Transport Statement

Land South of The Den, Richborough Road, Sandwich

DECEMBER 2023 PL/LC/17102

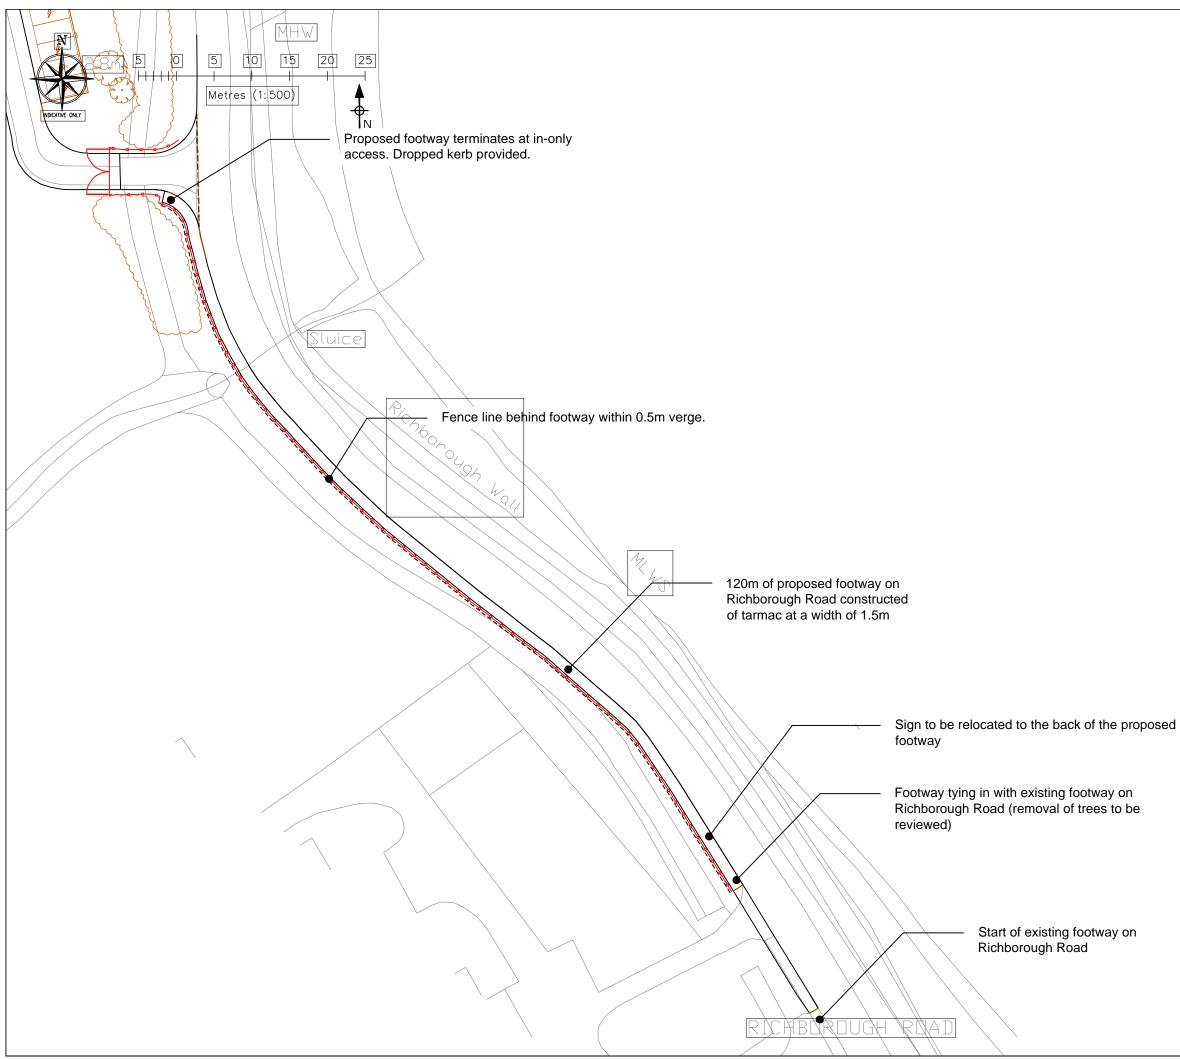
2.4	 Location: D – The 95m of footway along the verge of Richborough Road (Dwg. 17102/H-02 Rev. P2). Summary: Risk of pedestrians falling into the deep ditch. The verge on the west side of Richborough Road falls from what will be the back edge of the proposed 1.5m footway into the deep ditch that runs along this whole stretch of road (photo 1). Without a flat margin behind the footway onto 	Measures should be installed to ensure that pedestrians do not fall into the ditch.	Agreed. A fence line will be provided along the back of the proposed footway as showr in revised drawing 17102-H- 02 Rev P3. The form of the fence will be discussed with KCC Highways who will ultimately need to take on maintenance responsibilities.

2.6	Location: F – Southern end of the proposed footway (Dwg. 17102/H- 02 Rev. P2). Summary: Risk of pedestrian/vehicle	The proposed footway should continue southwards to join the existing footway.	Agreed. The plans have been updated in order to show a connection to the exist footway. There is a telegraph pole that will need t

2.7	Location: G– Towards the southern end of the proposed footway (Dwg. 17102/H-02 Rev. P2). Summary: Risk of pedestrian/vehicle collisions.	The speed limit pole and signs should be relocated to the verge behind the proposed footway.	Agreed. The speed limit pole will k relocated to the back of th footway as shown on drawing 17102-H-02 Rev P3.		
	The existing pole with the national speed limit/30mph signs is located in what will be the centre of the proposed footway. If left in situ, mobility impaired users will be unable to pass it on the footway and will have to travel on the carriageway for 120m to use the vehicle entrance to the development side, increasing their risk of

A fence line will be provided along the back of the proposed footway as shown in revised drawing 17102-H-02 Rev P3.

The bridge has now been removed so that the footway follows the carriageway.

Problems Location Plans

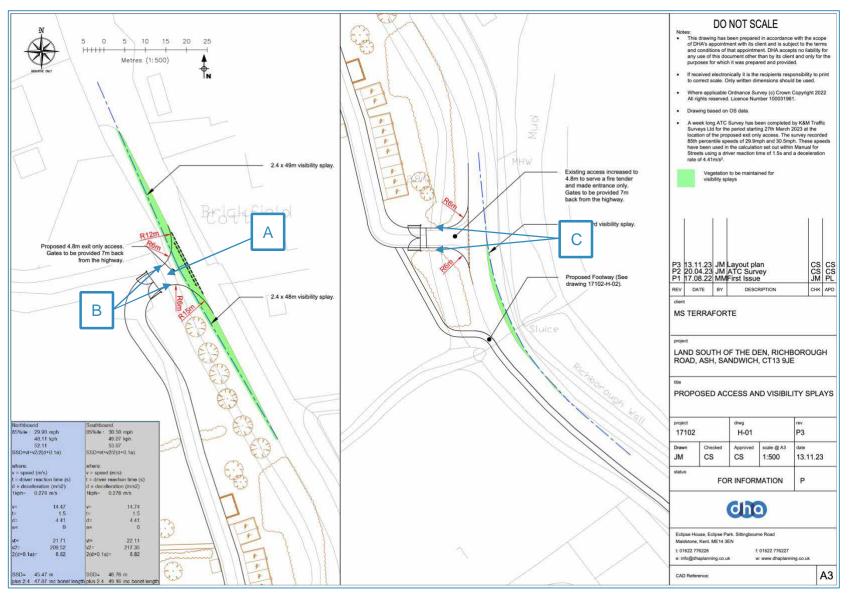
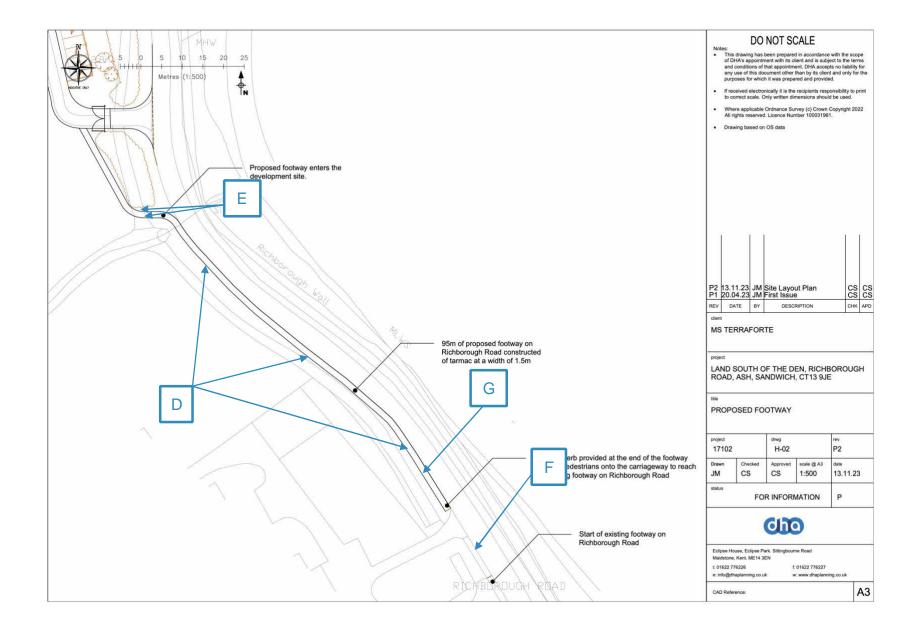
A relatively deep drainage ditch runs parallel to Richborough Road along the whole frontage of the site. The drawing implies that the exit road will be kerbed, but does not show any protection to stop an errant vehicle running off the side of the road into the drainage ditch as it turns the right angle to use the exit. The lack of a protective barrier, wall or verge on each side of the exit road, as it crosses the ditch, increases the risk of a vehicle falling into the ditch, with possible injuries to the vehicle occupants.

The drainage ditch that runs parallel to Richborough Road along the whole frontage of the site is particularly deep at the proposed access to the site. The drawing implies that the entry road will be kerbed, but does not show any protection to stop an errant vehicle running off the side of the road into the drainage ditch as it turns into the access. The lack of a protective barrier, wall or verge on each side of the exit road, as it crosses the ditch, increases the risk a vehicle falling into the ditch, with possible injuries to the vehicle occupants.

2.2	Location: B – The out- only egress onto Richborough Road (Dwg. 17102/H-01 Rev. P3). Summary: Risk of an exiting vehicle falling into the drainage ditch. A relatively deep drainage ditch tuns parallel to Richborough Road along the whole frontage of the site. The drawing implies that the exit road will be	The exit road should have protection on each side as it crosses the drainage ditch on the approach to Richborough Road.	Noted. Vehicles will be going a slow speed when exiting the site so risk is considered a low, however a fence will be provided either side of t access as shown on revisec drawing 17102-H-01 Rev P4.

2.3	Locations: C – The in- only access from Richborough Road (Dwg. 17102/H-01 Rev.P3). Summary: Risk of an entering vehicle falling into the drainage ditch. The drainage ditch that runs parallel to Richborough Road along the whole frontage of the site is particularly deep at the proposed access to the site. The drawing implies that the entry road will be kerbed, but does not show any	The access road should have protection on each side as it crosses the drainage ditch next to Richborough Road.	Agreed. Fences will be provided either side of the access order to provide protectior where the access crosses the ditch as shown on revis drawing 17102-H-01 Rev P4.
